Consultee Comment for planning application P/OUT/2023/01166

Internal LLFA Consultation – Surface Water (SW) Management

Our Ref: PLN23-020/2

Location: Land To The South Of Ringwood Road Alderholt

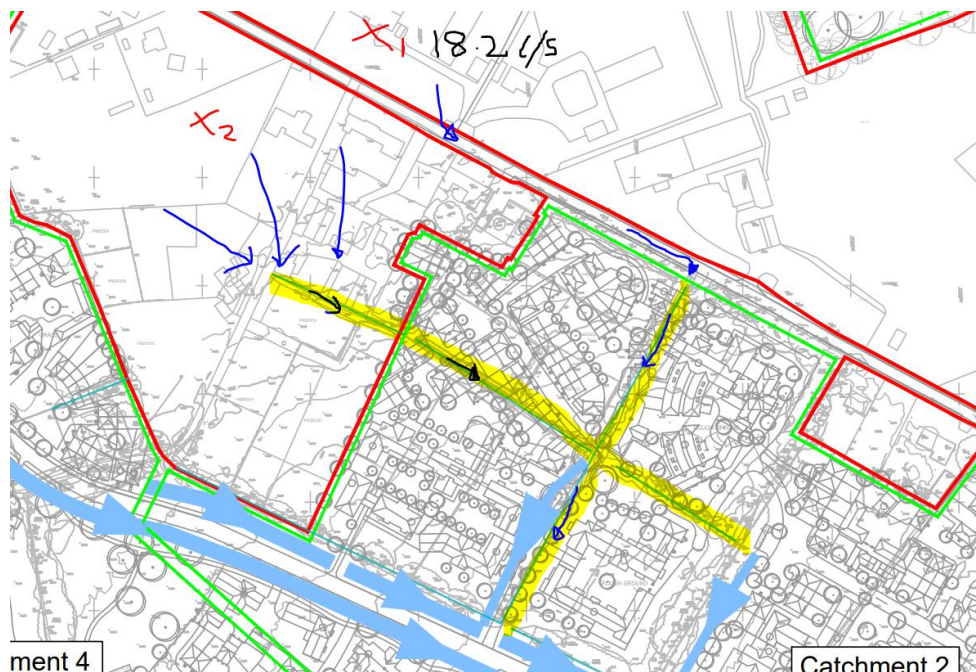
1. The figure below is an extract from the applicant's Flood Risk Assessment. An approved development (3/16/1446/OUT) in the uppermost part of 'Catchment 2' marked as X1, has an attenuated discharge of 18.2ls into an existing ditch (approximate location of discharge shown on figure). There is another upstream catchment marked as X2. Both of these catchments discharge through the site along open drainage lines - marked in yellow highlights. The applicant's drainage strategy does not consider these drainage lines. The future layout is shown to be located over these drainage lines with houses shown to be built over the drainage lines. Open drainage lines should be left as open drainage lines where possible. Culverting of watercourses is not permitted, and culverting of drainage lines is discouraged; where a drainage line has to be culverted for any length then an overland flow route will be required. There is an increased flood risk to the proposed development and upstream third-party property because these drainage lines have not been continued through the development; no alternative channel has been proposed. No assessment of the impact of removing these drainage lines has been included in the Flood Risk Assessment.

Insufficient assessment of the flood risk from the upstream catchment, and how this will be managed, has been undertaken as part of the Flood Risk Assessment.

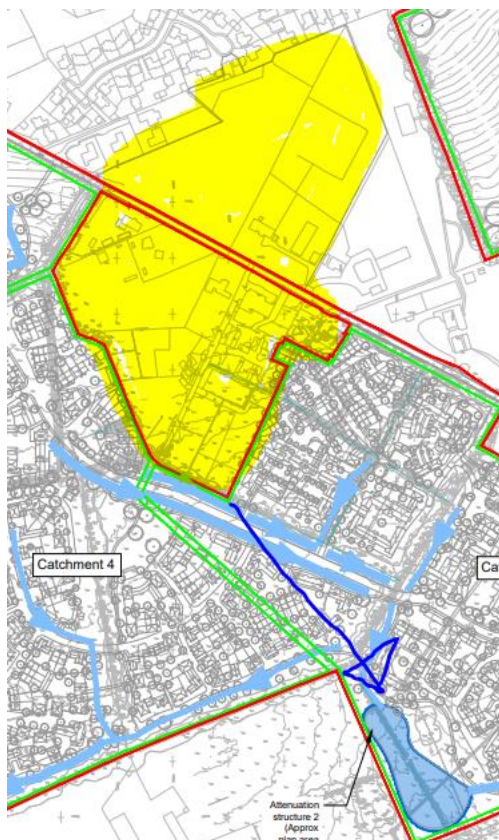
4. Attenuation Basin 2 will also receive discharge from the upstream catchment shown in yellow highlights on the figure below. Attenuation Basin 2 has not been sized to receive flow from this upstream catchment. Therefore, Attenuation Basin 2 may be undersized. This has the potential to increase flood risk downstream from the basin, which is third-party land. The area allowed for this attenuation basin is also quite constrained without much scope for increasing its size with regards to area.
